GATE, S.N. 443,300

R E M A R K S

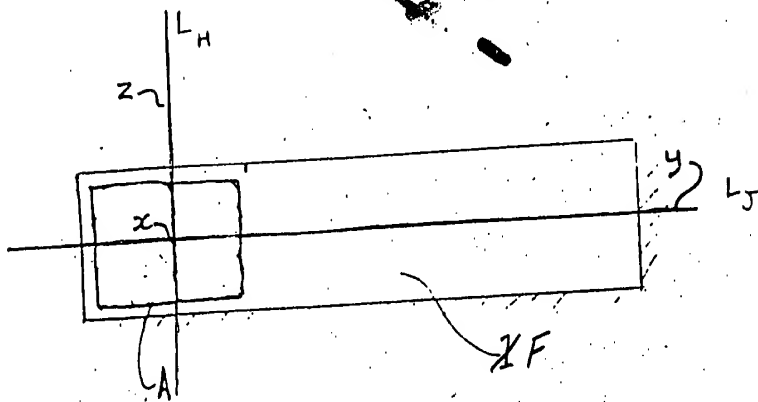
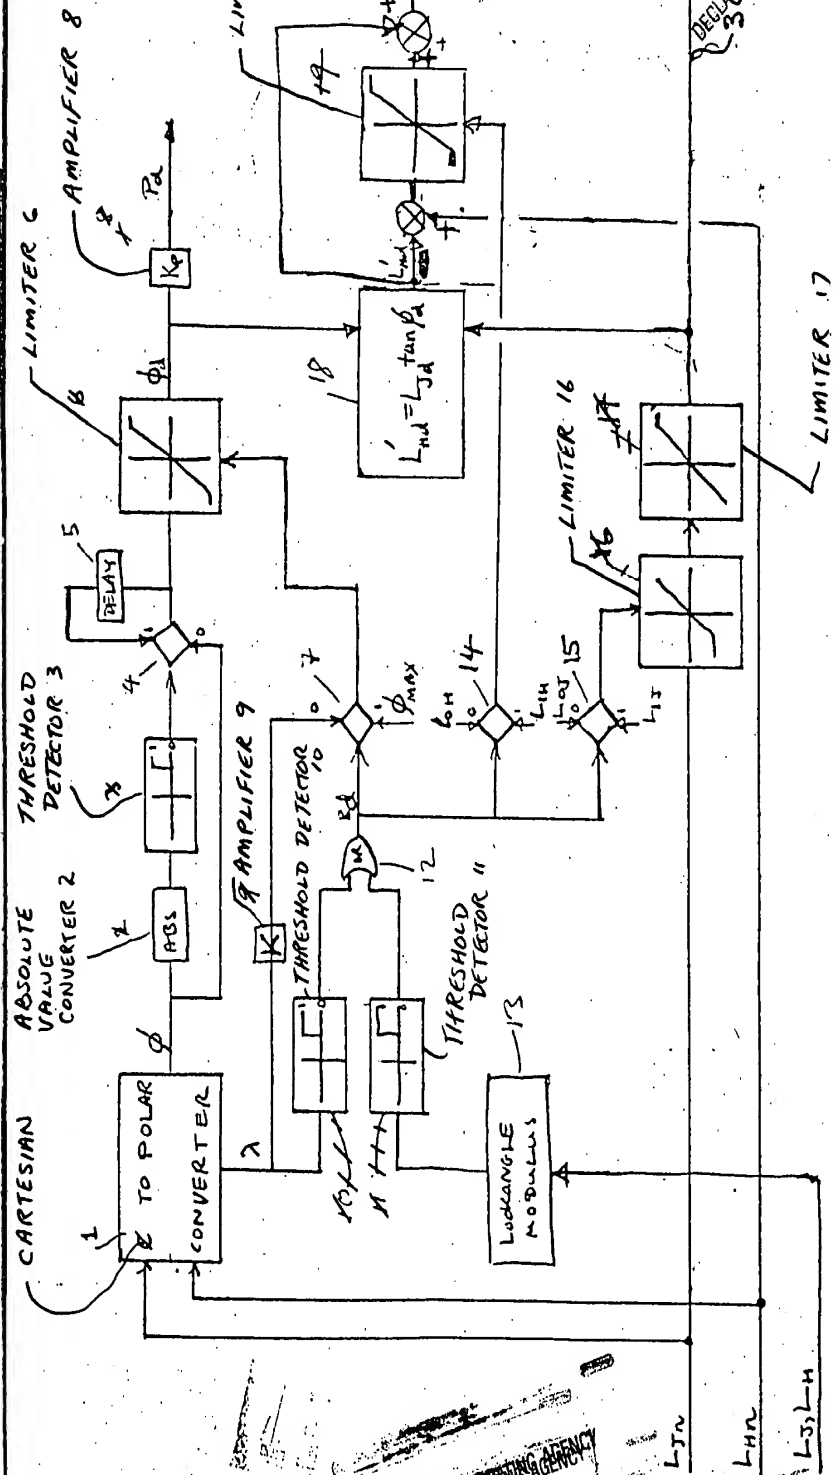
The drawings were objected to because in Figures 1 and 2 the numeral "1" denoted two different elements and the rectangular blocks in Figure 2 were unlabelled. By separate paper filed herewith entitled "Request for Approval of Drawing Corrections", drawing corrections are requested for overcoming these objections.
